DIMENSIONS ARE INCHES (UNLESS OTHERWISE SPECIFIED)	DTAC No. 07-01438 Radiator Mnt Cond.
TOLERANCES (EXCEPT WHERE NOTED) 1 PLC. DEC. ± 2 PLC. DEC. ± .157 3 PLC. DEC. ± .157 HOLE DIA. ø ± .005 ANGULAR ± 2°	
DO NOT SCALE DRAWING

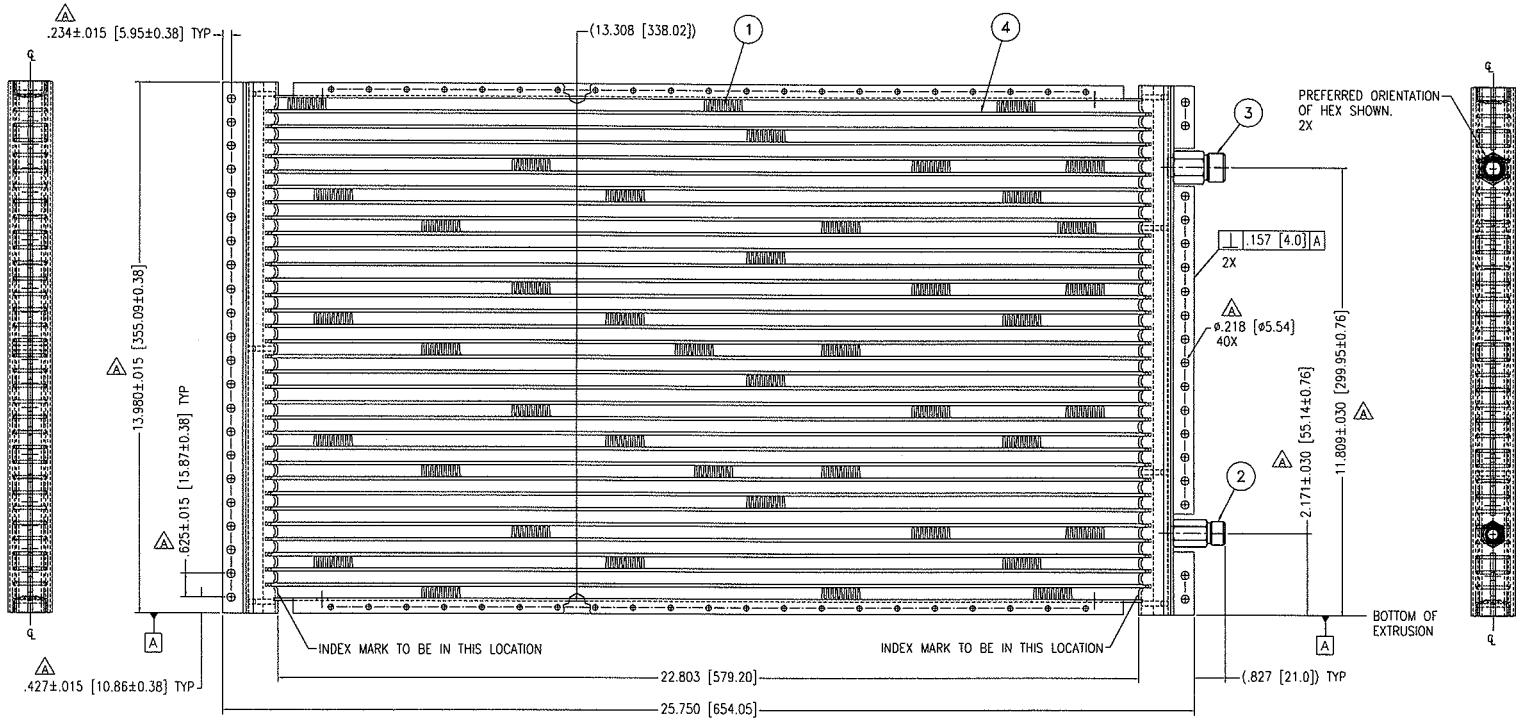
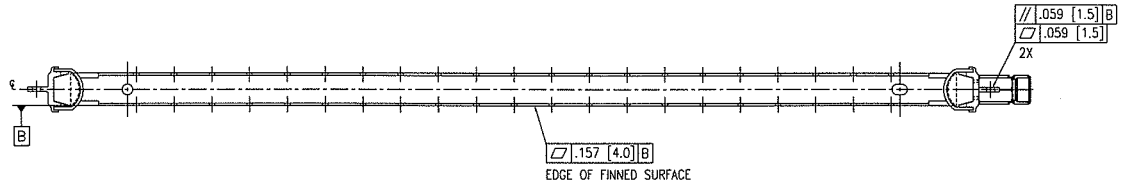
DATE	SYM	REVISION RECORD	ECN	AUTH.	DR.	CK.
2-18-08	A	ADDED 57-0335 ITEM 4. ADDED NOTES 7 & 8. SUFFIX DELETED FROM P/N'S IN CHART. ADDED TOLS. TO FTGS. AND EXTRUSION. UPDATE DIMS. EDM. TOLS. ADD COMON. TOLS. TO MOUNT STRS. ADDED HOLES CALL OUT & DIMS. PROT. PLATE & HEADERS DEL FROM CHART. ITEMS IN CHART REMUNDERED. NOTE 1 REWORDED.	27173	RS	LG	LG
